Texas Department of Housing and Community Affairs

Board Action Request

Presentation, discussion, and possible action regarding a Material Amendment to the Housing Tax Credit Application for Melody Grove II (HTC #25204)

Request for Amendment Approving Changes to Site Plan and Unit Configuration
Modifications

A1.1
OF SHEETS

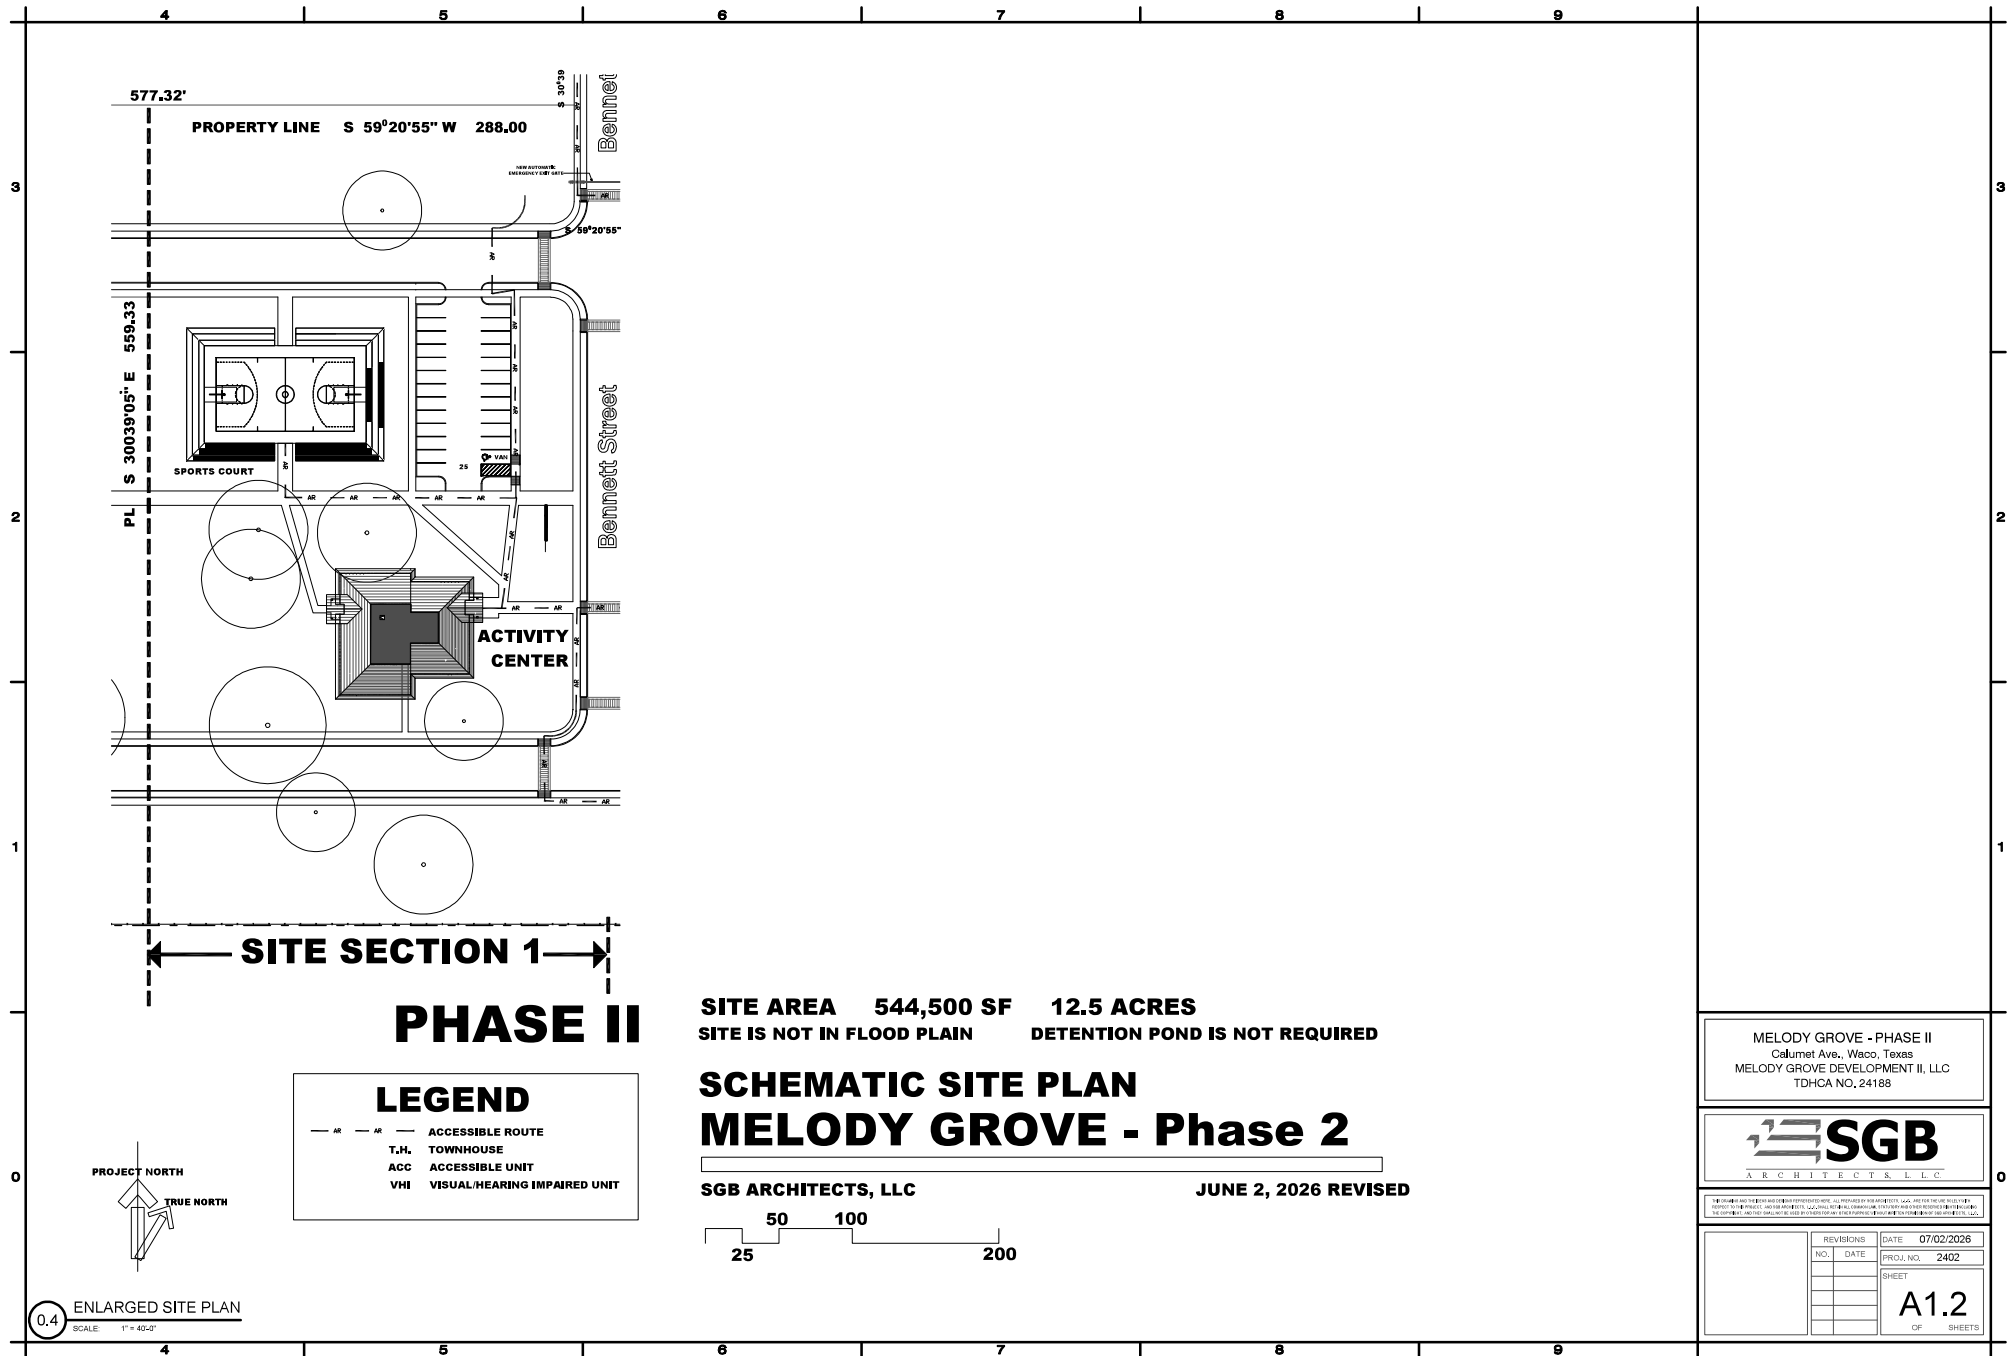
As part of this revision, the development team is eliminating fourteen (14) previously proposed stand-alone residential buildings (Building Types B3, B4, and B5). The project will instead contain 8 buildings, consisting of three (3) primary building types (Types A, B, and C). This modification is necessary as it significantly simplifies the construction approach, improves overall site efficiency, and reduces development complexity, which is particularly important in the current cost environment. Additionally, the design for the Activity Center is being simplified. The current square footage of the Activity Center is 6,196 and the new square footage will be 6,481, a slight increase. The simplification in design will help offset costs as well as add more usable square footage.

In addition, these changes are necessary to address potential Fair Housing and Equal Opportunity (FHEO) concerns associated with the original design of this townhome style development. By eliminating stand-alone buildings, some of which were designated for accessible (ACC) units, the revised plan integrates these units within the primary residential buildings. This approach promotes a more uniform distribution of accessible units throughout the development and avoids the appearance or risk of segregation of residents based on accessibility needs.

A4.0
 OF SHEETS

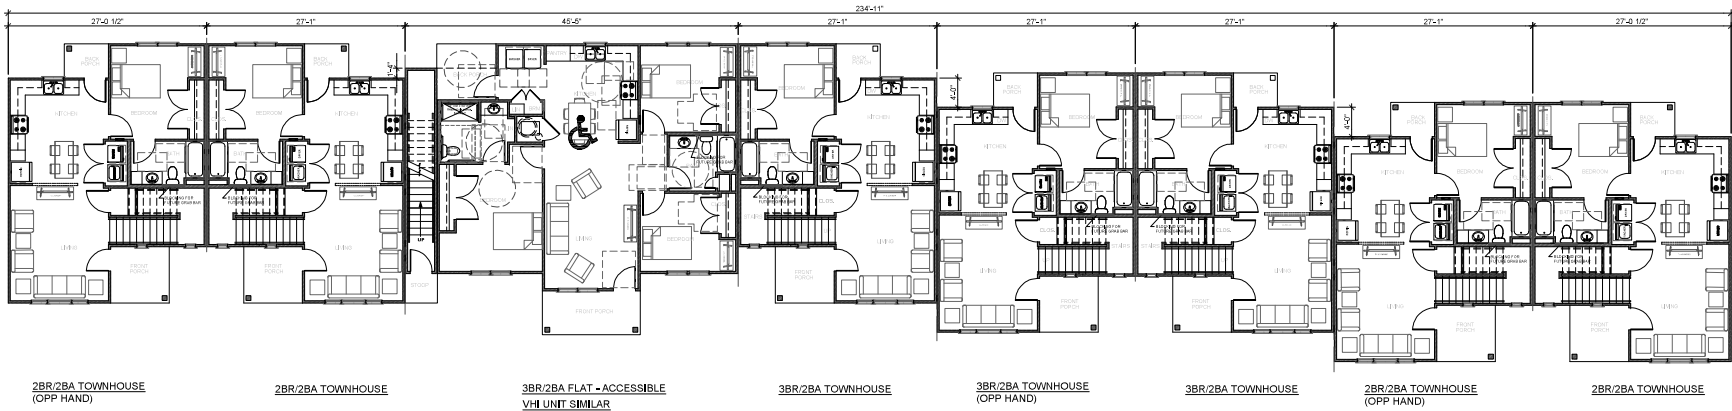
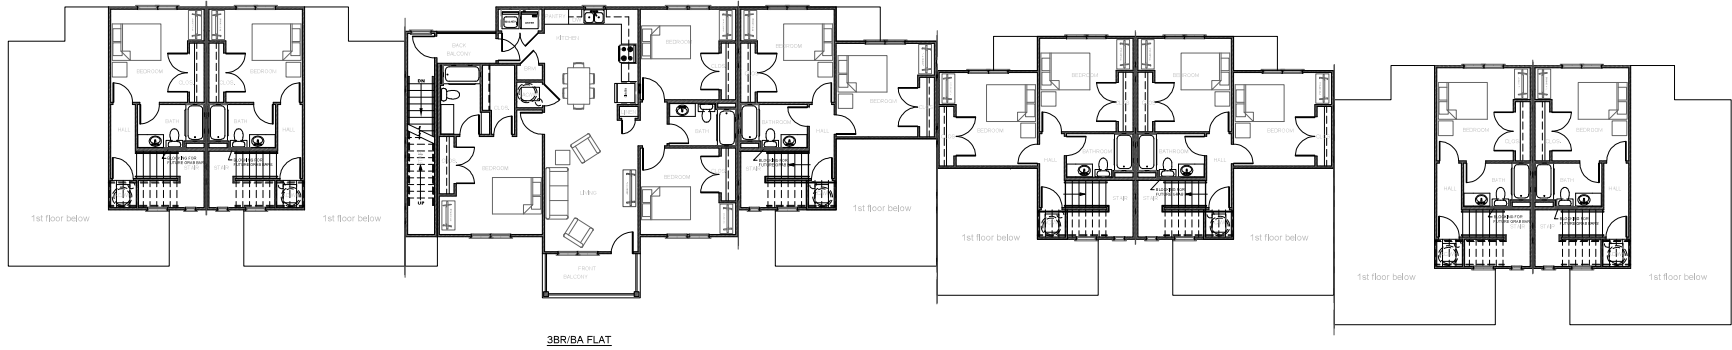
The relocation of accessible units into the primary building footprints, and overall redesign of the site plan, required adjustments to the unit layouts. As a result, the total net rentable square footage has been reduced from 90,866 square feet to 84,366 square feet, representing an approximate 7% decrease. These reductions were carefully implemented to ensure that all units remain functional, marketable, and fully compliant with TDHCA program requirements and the unit sizes exceed the minimum sizes outlined in the selection criteria by at least 20% (See exhibit A for a unit by unit comparison to minimum unit size.)

Further, following coordination with the Waco Housing Authority and input from prospective resident needs, the Applicant has redesigned the accessible units to be located exclusively on the ground floor as single-level flats. This modification eliminates the need for chair lifts within the townhome units, improving accessibility, safety, and long-term maintenance considerations. Each accessible unit will have a corresponding non-accessible unit directly above with a similar layout, maintaining architectural consistency across the buildings.
